HATCH - UNIT 2

NRC DOCKET 50-366
OPERATING LICENSE NPF-5
EDWIN I. HATCH NUCLEAR PLANT UNIT 2
REQUEST FOR TECHNICAL SPECIFICATION AMENDMENT
TO SUPPORT OPERATION IN THE ELLA REGION

NRC DOCKET 50-366
OPERATING LICENSE NPF-5
EDWIN I. HATCH NUCLEAR PLANT UNIT 2
REQUEST FOR TECHNICAL SPECIFICATION AMENDMENT
TO SUPPORT OPERATION IN THE ELLA REGION

FIGURE 3.4.1.1-1
THERMAL POWER LIMITATIONS DURING OPERATION WITH LESS THAN
TWO REACTOR COOLANT SYSTEM RECIRCULATION LOOPS IN OPERATION

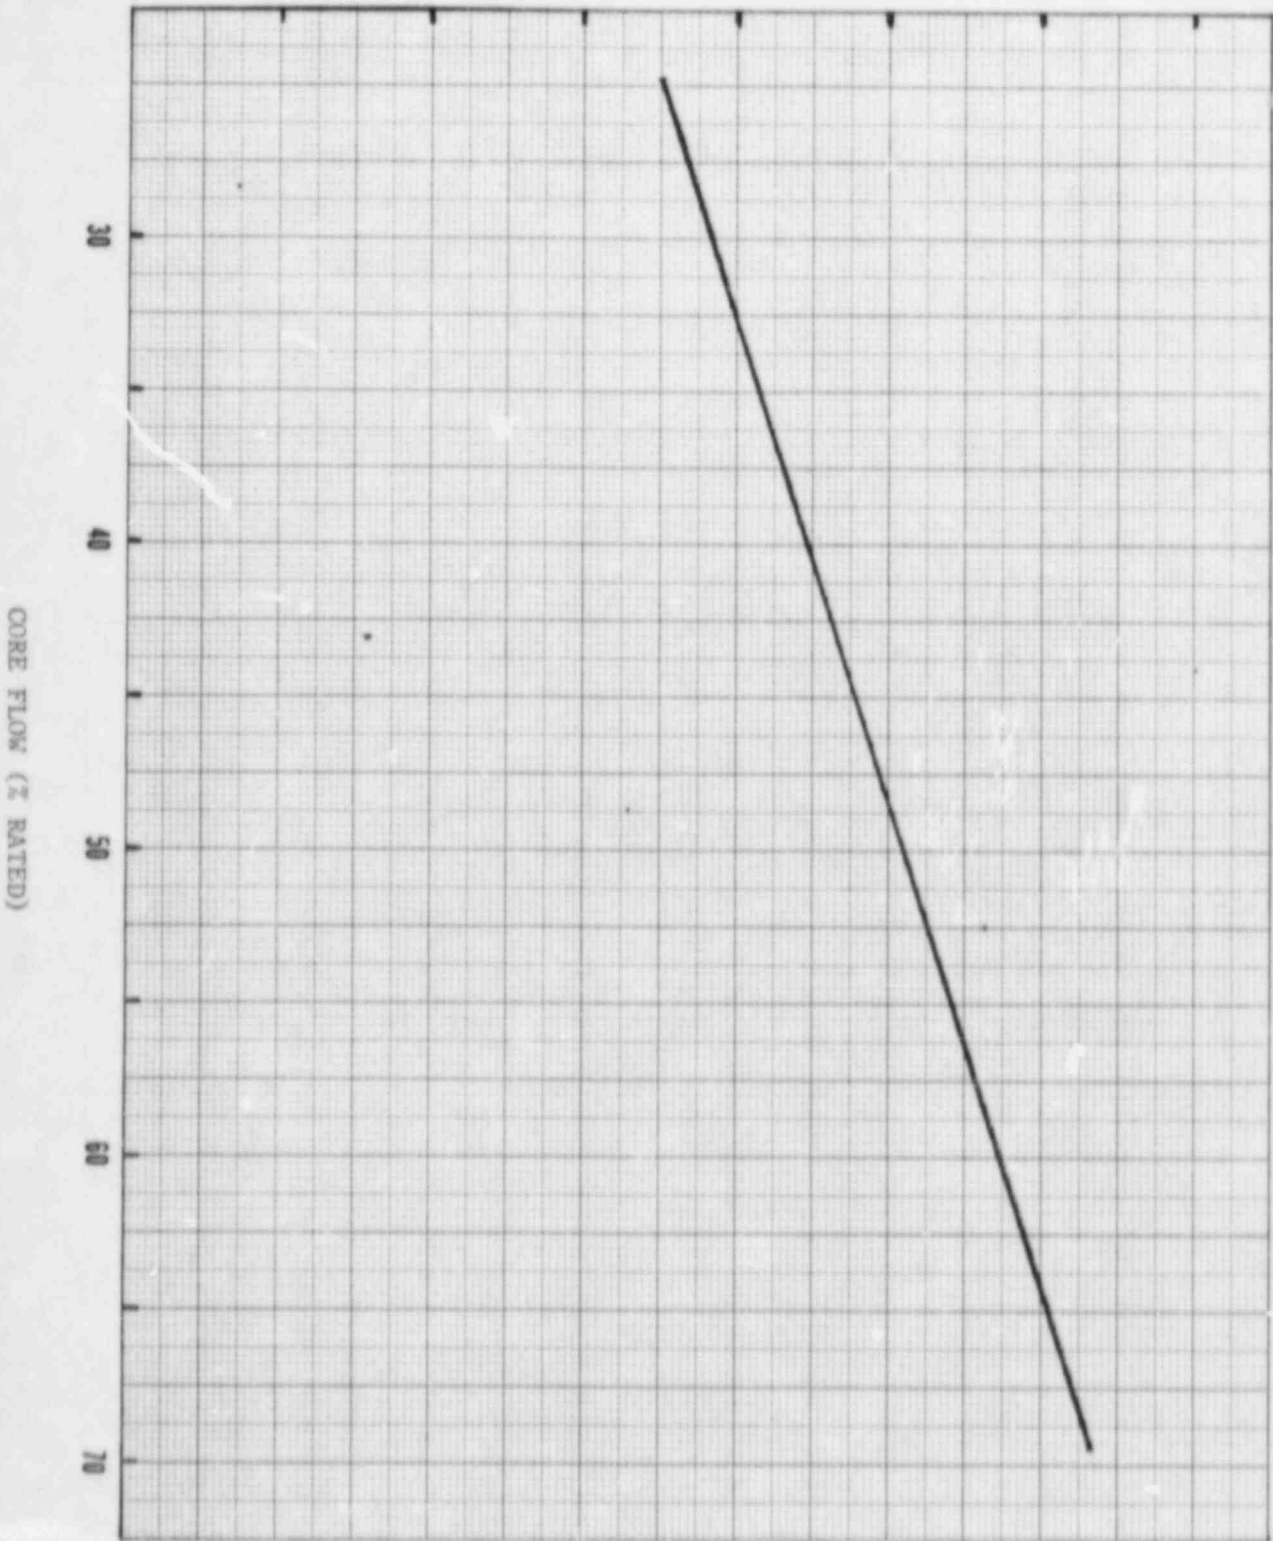
Replace "...operation may continue;..." with "...initiate action within 15 minutes and continue action to reduce reactor power to or below the limit specified in Figure 3.4.1.1-1 within 2 hours and..." in ACTION 3.4.1.1.a, and add Figure 3.4.1.1-1 as a new page (3/4 4-1a).

This change would restrict plant operation to the region at or below the limit shown in Technical Specification Figure 3.4.1.1-1, within 2 hours after either recirculation loop is declared inoperable. That limit corresponds to a load line leading to 80% reactor power at rated core flow. This constitutes an additional restriction not presently in the Technical Specifications; therefore, this proposed change is consistent with Item (ii) of the "Examples of Amendments that are Considered Not Likely to Involve Significant Hazards Considerations" listed on page 14,870 of the April 6, 1983, issue of the Federal Register.

- a. With one recirculation loop not in operation, initiate action within 15 minutes and continue action to reduce reactor power to or below the limit specified in Figure 3.4.1.1-1 within 2 hours and restore both loops to operation within 12 hours or be in at least HCT SHUTDOWN within the next 12 hours.
- b. With no recirculation loops in operation, place the reactor mode switch in the Shutdown position.
